**RE: Request for Further Information of Amberfield Development,
Peacockes Road, Hamilton**
(Our Reference: 14280.000.000_21)

ENGEO Ltd was requested by Weston Lea Limited to prepare a response to the Request for Further Information letter received from Hamilton City Council dated 5 July 2018. We have been asked to respond to particular questions (as detailed below) and understand that the remaining queries will be answered by other members of the consulting team.

Figure 1: Typical Counterfort Drain Detail

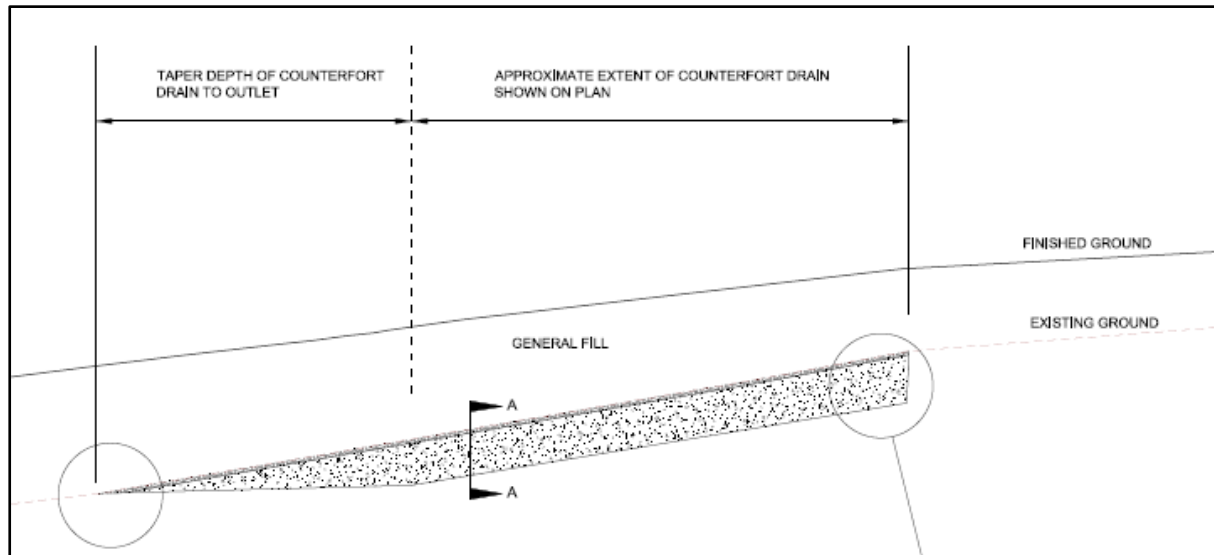
5. Provide more detail on the installation methodology; e.g. will the lower sections of the counterfort drains be installed via open trench with directional drilling at the slopes?

Counterfort drainage will be constructed as per the standard detail (Appendix 8C) included in Appendix 8 of the ENGEO Geotechnical Investigation Report (GIR) supplied as part of the application package.

It is intended that counterfort drains will be constructed from existing ground levels and will taper out at the end to meet existing ground levels adjacent to the esplanade reserve. Fill will then be placed as required within the drained area as shown on Figure 1. The depth of the drains will be reduced at the downslope end to exit the drains and a collection manifold drain will be installed parallel to the river, to connect the drains to a common outlet point. This is shown on drawings SK 281 & 282.

This methodology means that construction will be undertaken via hydraulic excavator using open cuts. No thrusting will be required to form outlets.

GEOLOGICAL SECTIONS

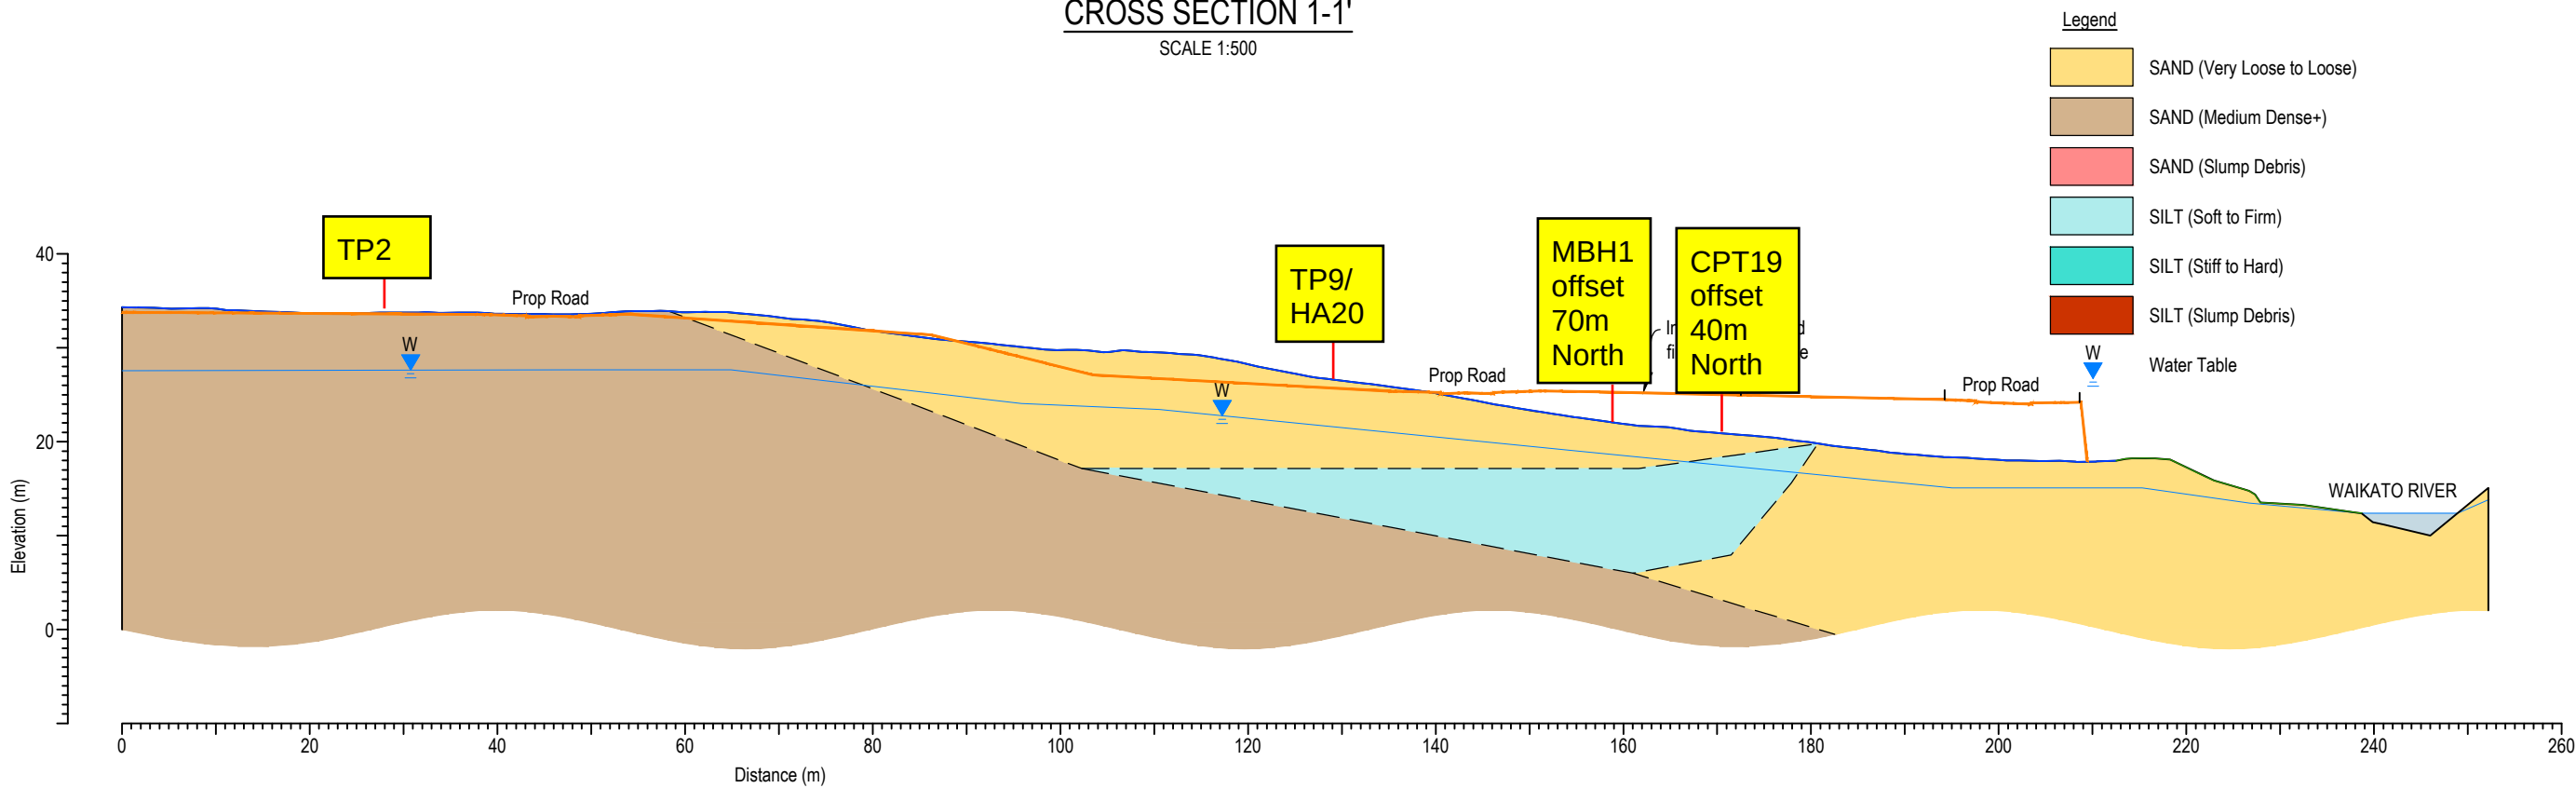
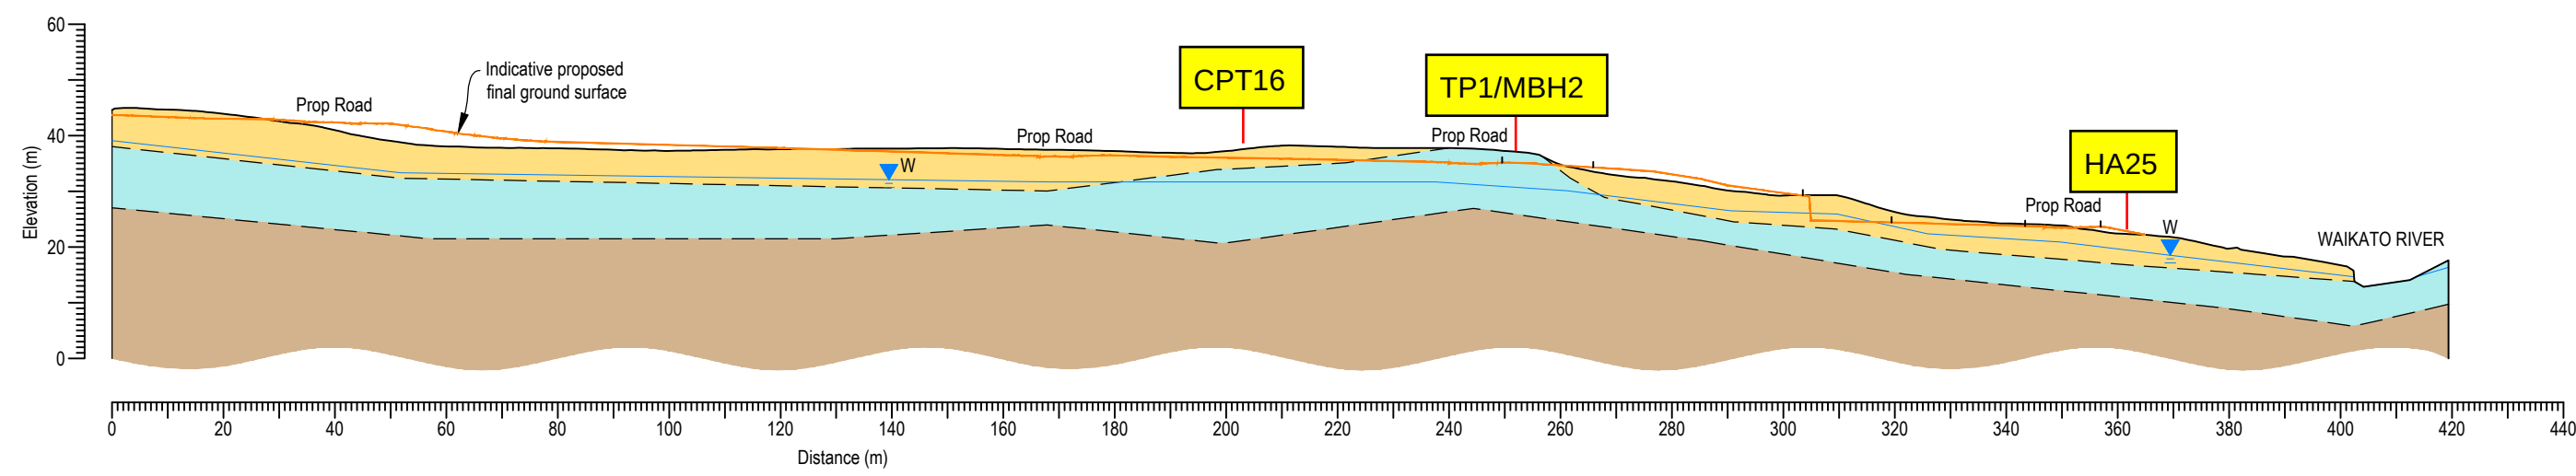
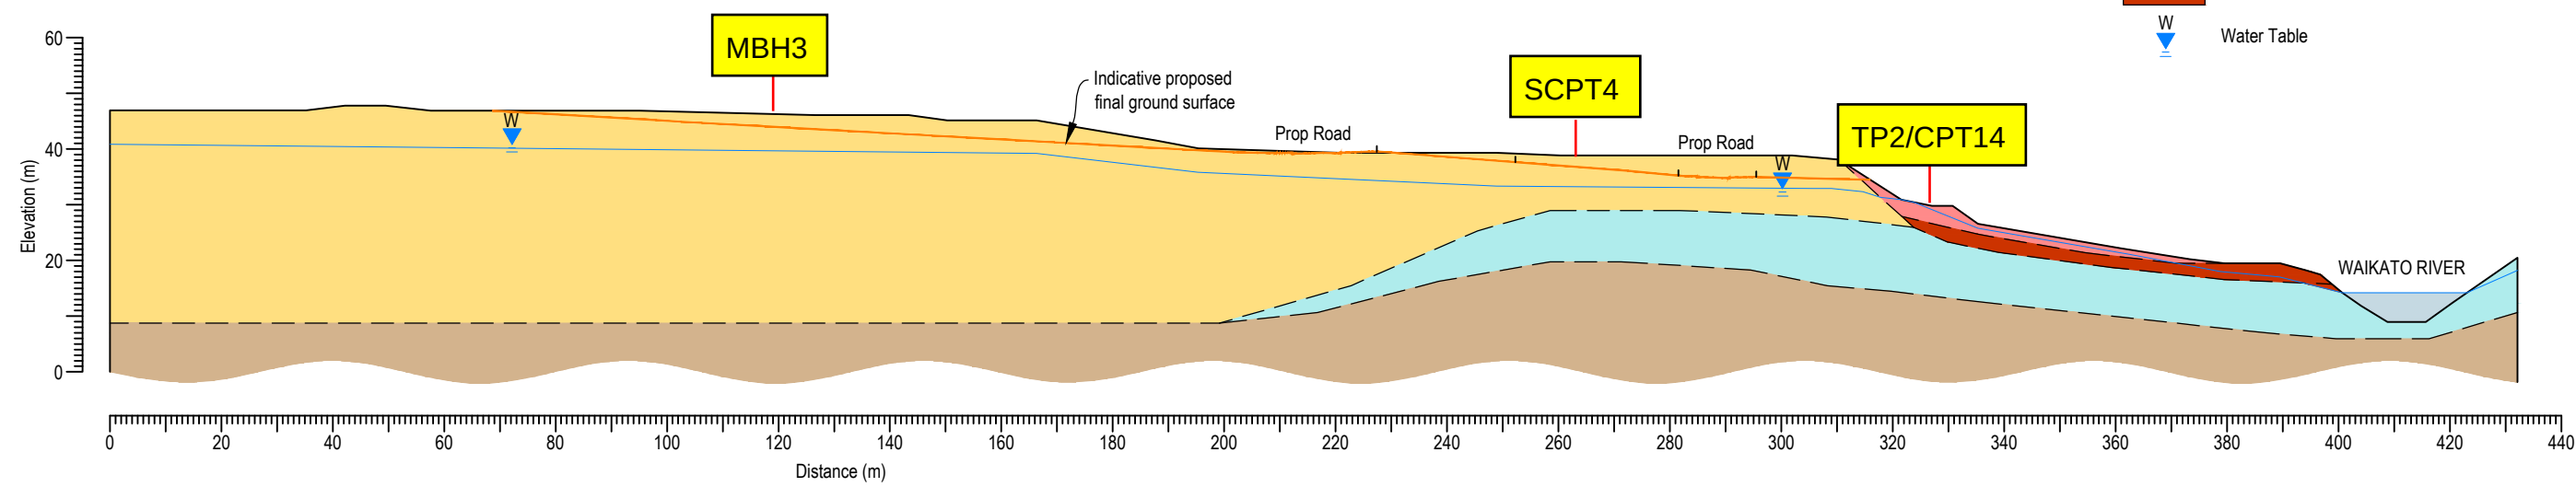
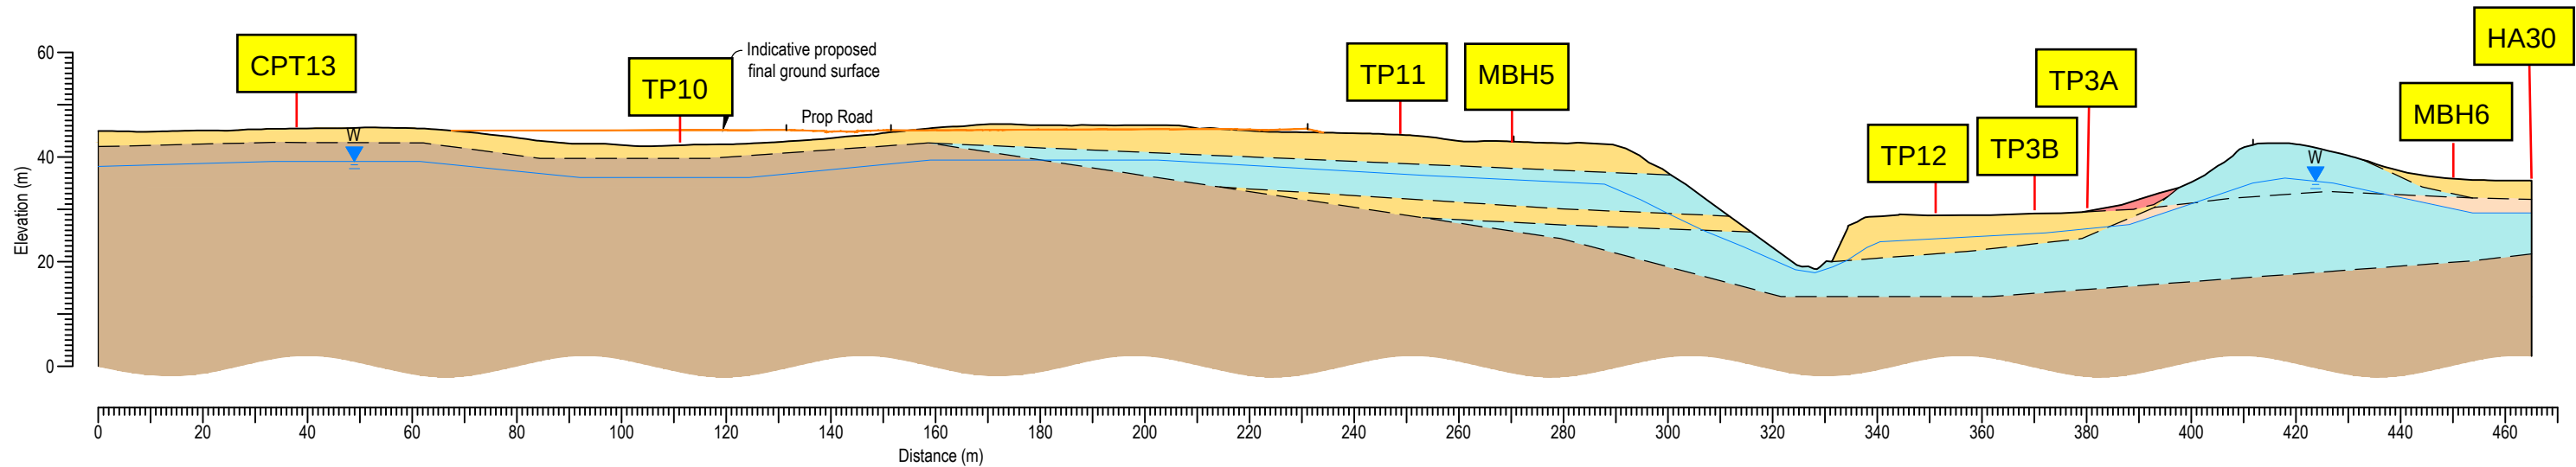
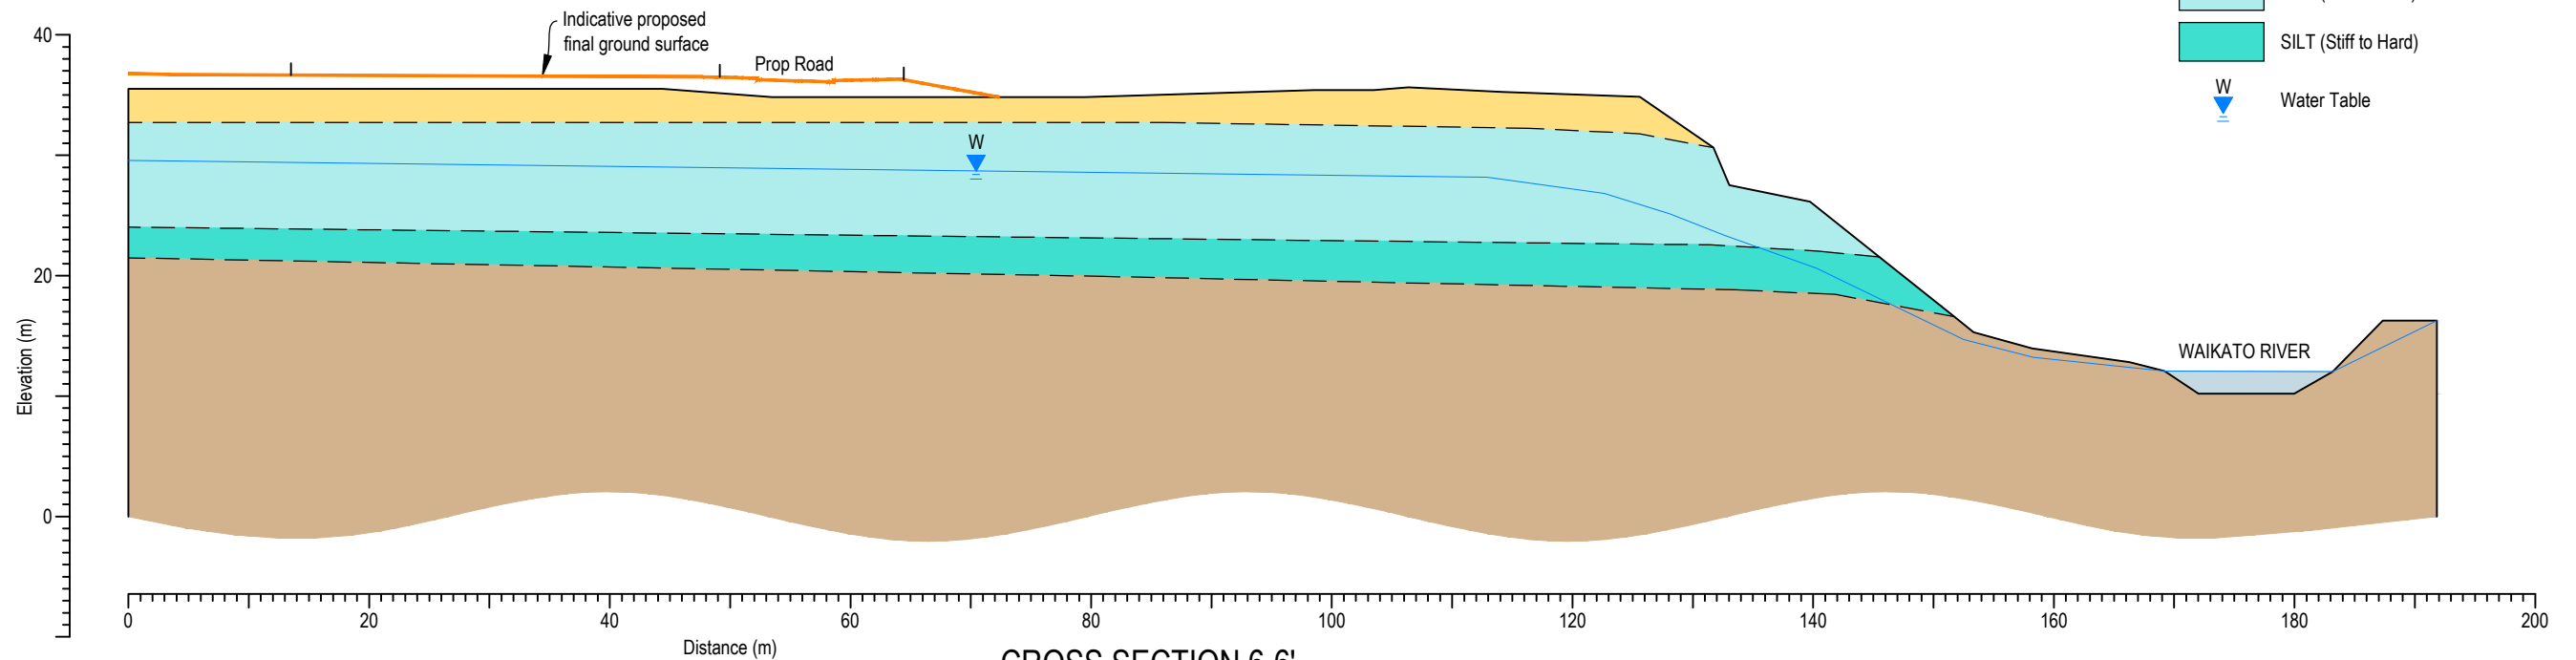
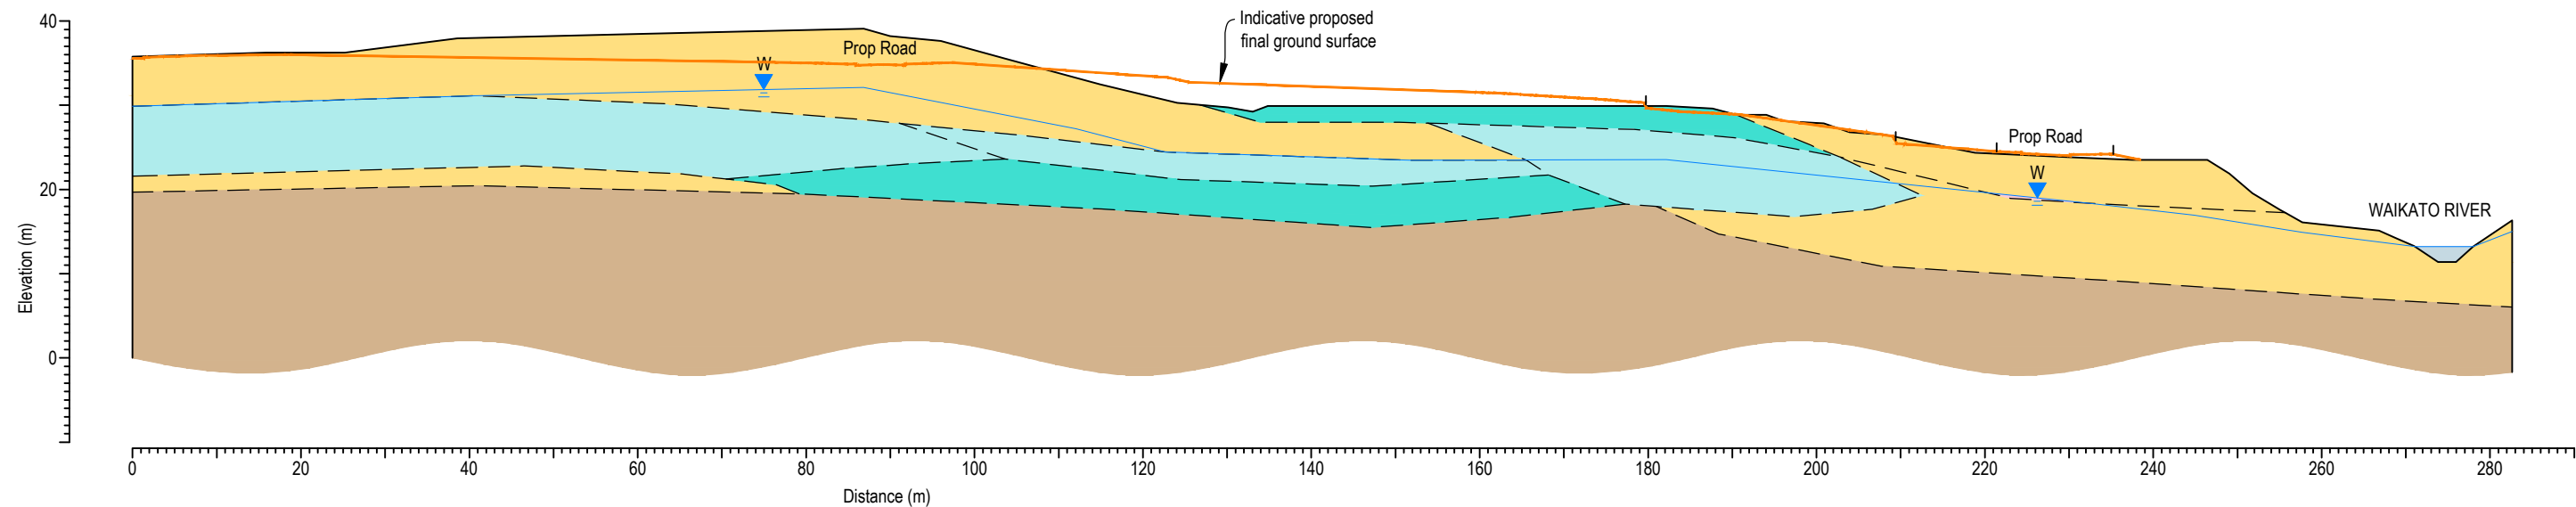
36. *The slope stability assessments appear to use the soil models given in the geological sections in Appendix 8 of the Interim Geotechnical Investigation Report. These cannot be reviewed effectively without the borehole information superimposed. The assessment makes an assumption that the hard layer encountered at the base of the CPT investigations is continuous with depth (Section 13.1). It is not possible to review this claim as the data has not been provided and it is not clear what the geological unit is. The geological units in question are highly variable so the assumption that this layer is continuous with depth is not necessarily sound and should be justified. Please provide substantiation for assumptions made in the geological model.*

Please find updated geological sections attached.
